K9-Prisoner Compartment system

K9-Prisoner Compartment system

Option 1: Full K9 Compartment

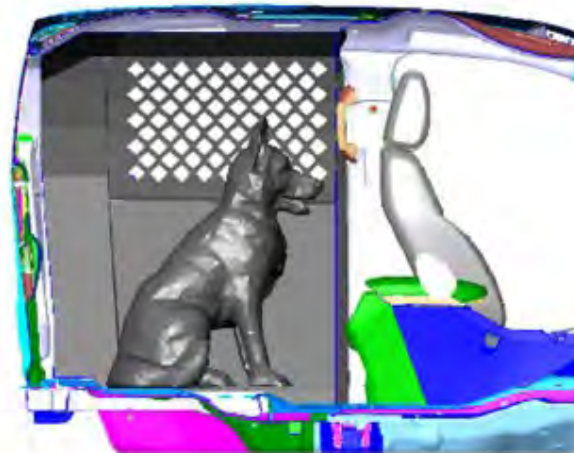
- Floor to be thick of rubber to support the Dog.
- Air Conn or window down for Dog when the vehicle shutdown.

Floor to be thick of rubber to support the Dog.

Option 2: K9 Compartment 60% Prisoner Compartment 40%

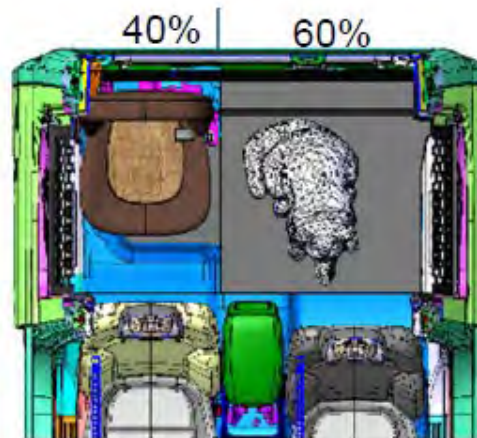
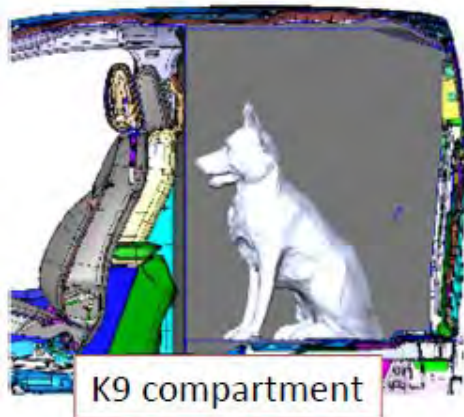
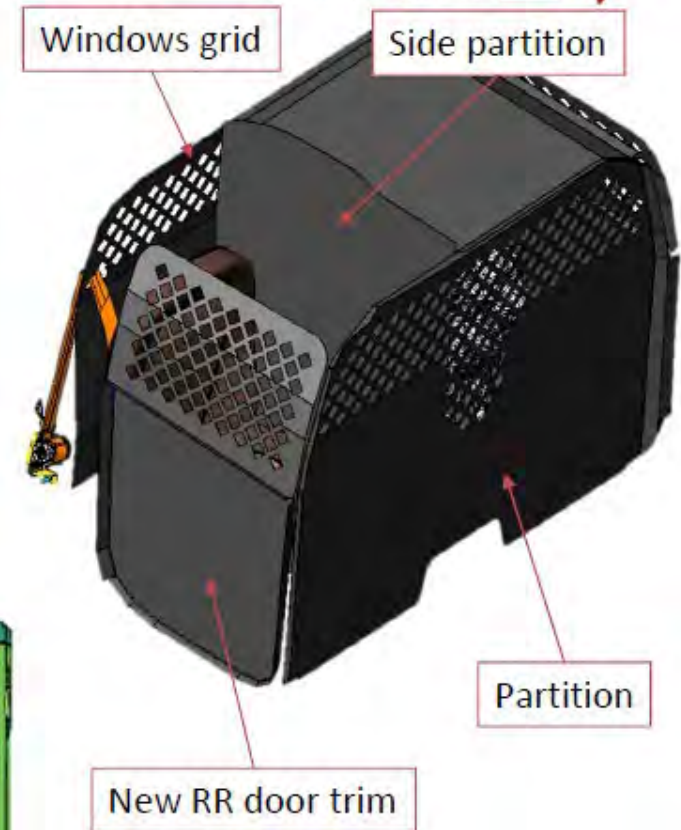
- Rear Seat for Prisoner to be protected no anything to add inside, hard material or cover to protect.
- Floor to be thick of rubber to support the Dog.
- Air Conn or window down for Dog when the vehicle shutdown.

Option 3: Full Prisoner Compartment

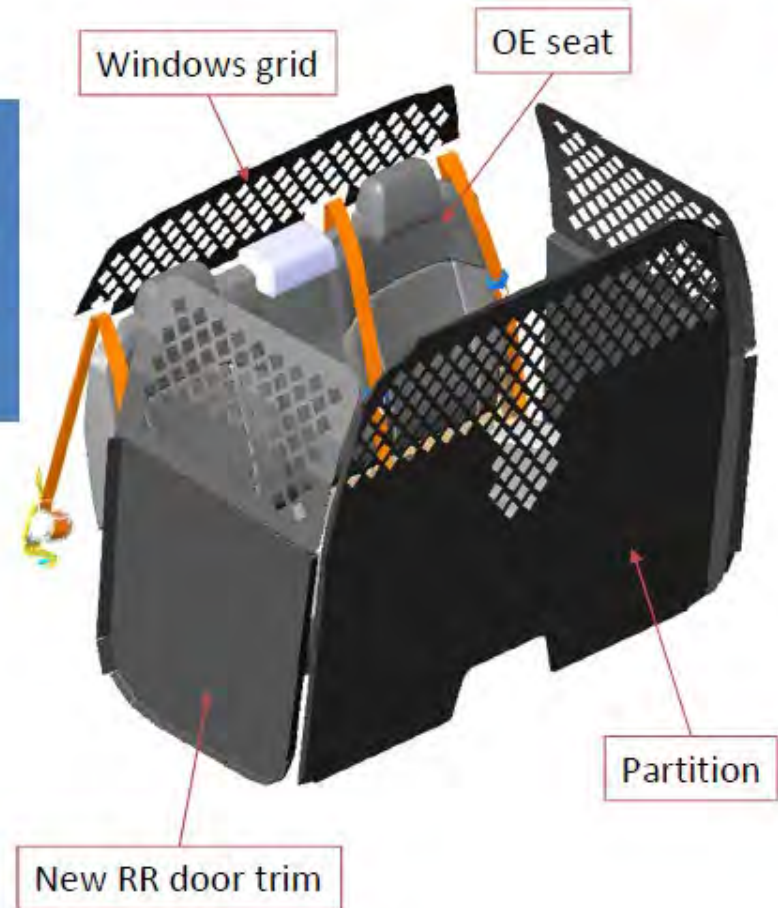
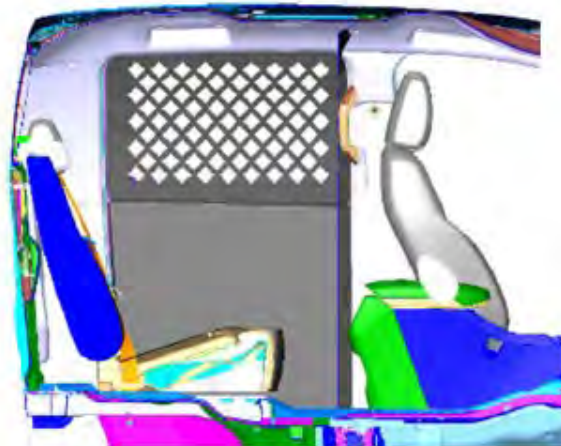
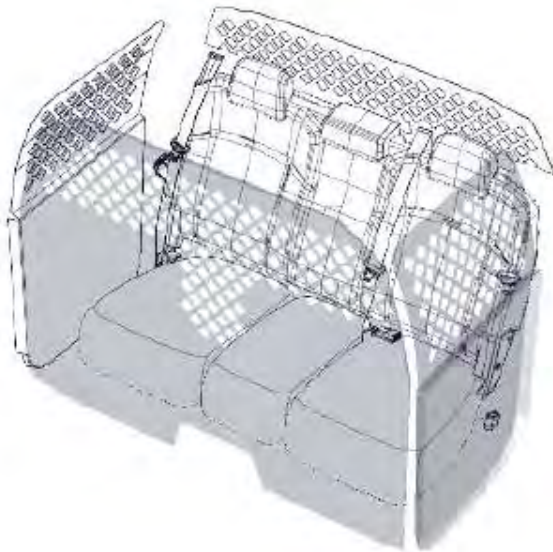
- Rear Seat for Prisoner to be protected no anything to add inside, hard material or cover to protect.
- Air Conn or window down for Dog when the vehicle shutdown.
